Subject: **Site Plan Special Permit #07/03/14 - #450 – Concord Public Schools – 37 Knox Trail**

To: Scott Mutch, Town of Acton Zoning Enforcement Officer
From: Chris Allen, District Manager
Re: Comments on SPSP #07-03-14-450/ 37 Knox Trail, Acton, MA

RE: Nitsch Project #10079
Continuation of Use
37 Knox Trail
Acton, MA

C4.0

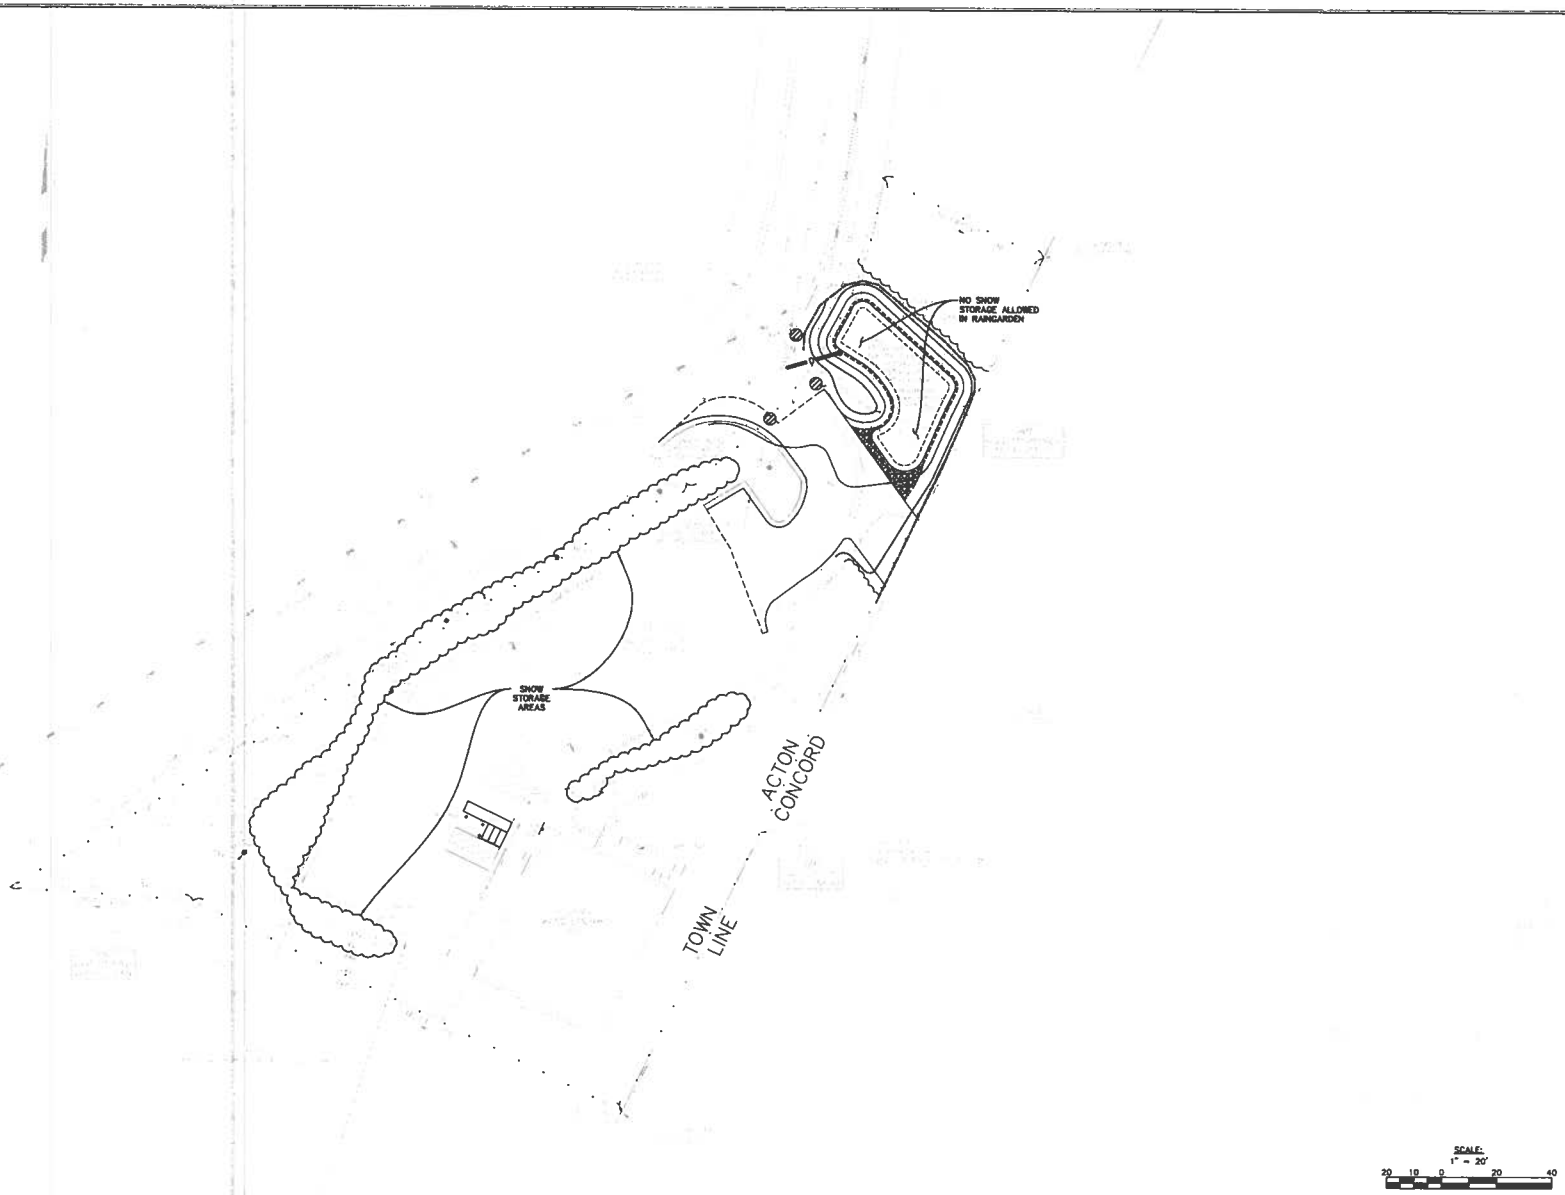
3. A snow management plan for the site should be prepared or updated. This needs to demonstrate how the applicant plans to conduct winter maintenance of this parking area and should identify adequate areas for snow storage, ensuring that the proposed rain garden is not utilized for this purpose.

C2.0

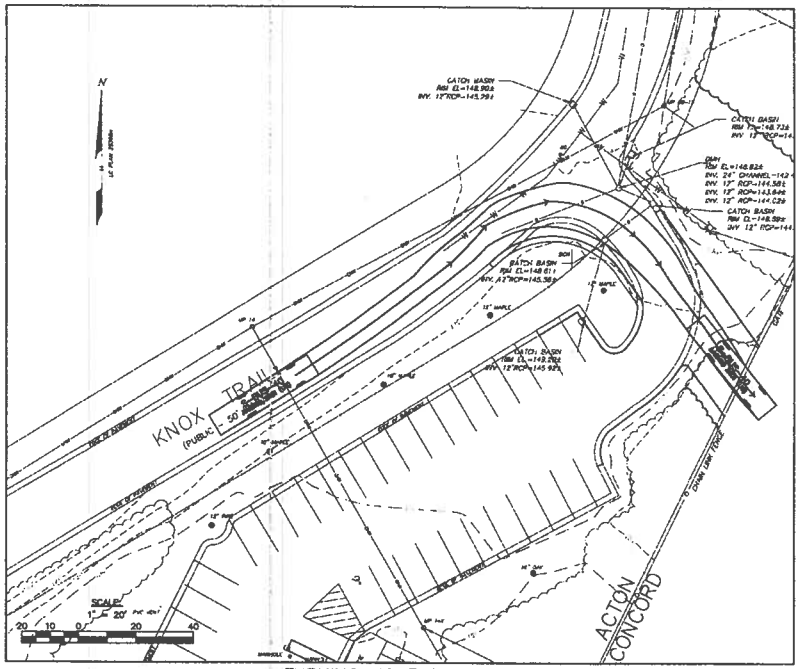
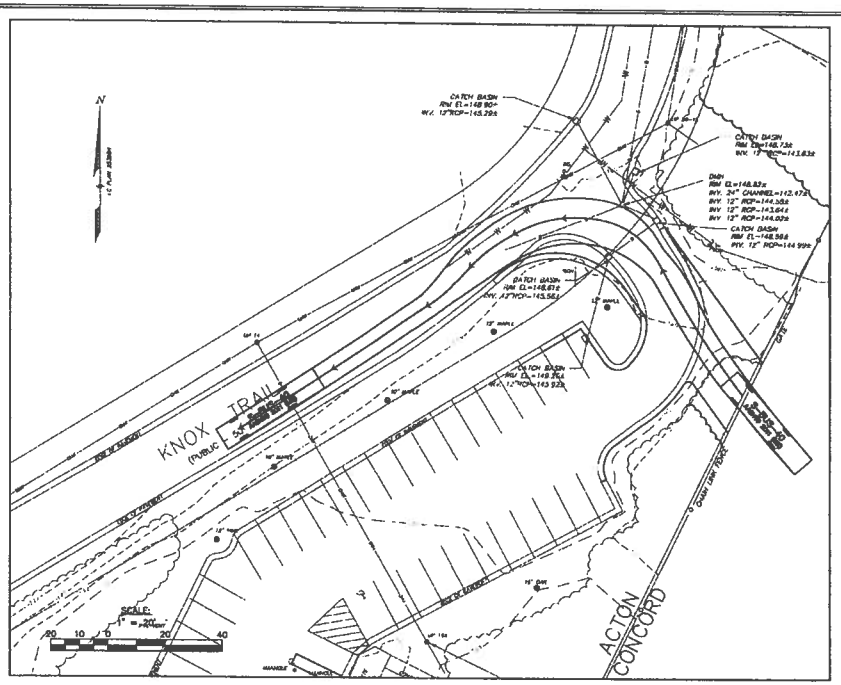
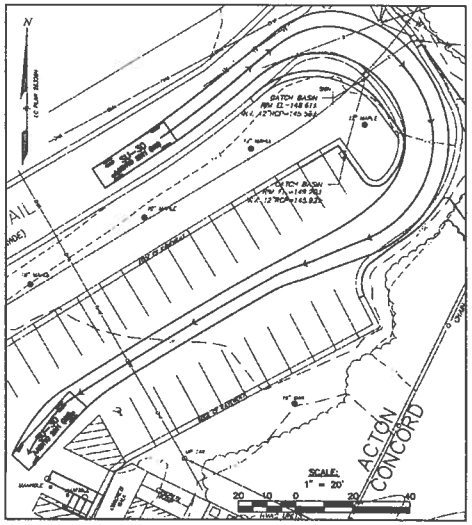
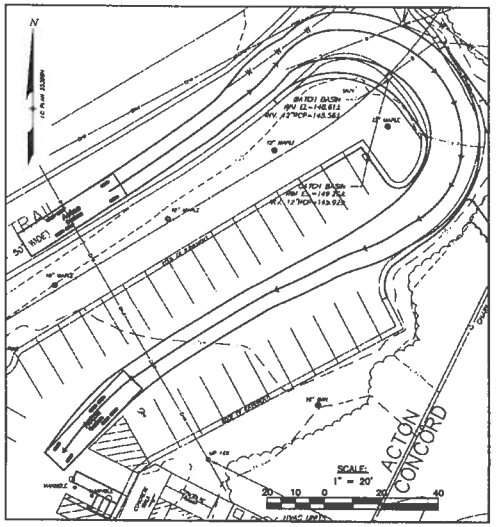
Ladder 28 is our longest vehicle.
The wheelbase is 247.00 inches
The cramp angle is 45 degree max.
Calculated Turning Radius
Inside Turn: 19 ft. 7 in
Curb to Curb: 35 ft. 6 in
Wall to Wall 40 ft. 0 in

Nitsch Engineering received fire truck turning information from the Acton Planning Department in an e-mail, dated October 15, 2014, which was used to create the turning movement drawing for 37 Knox Trail on Sheet C2.0.
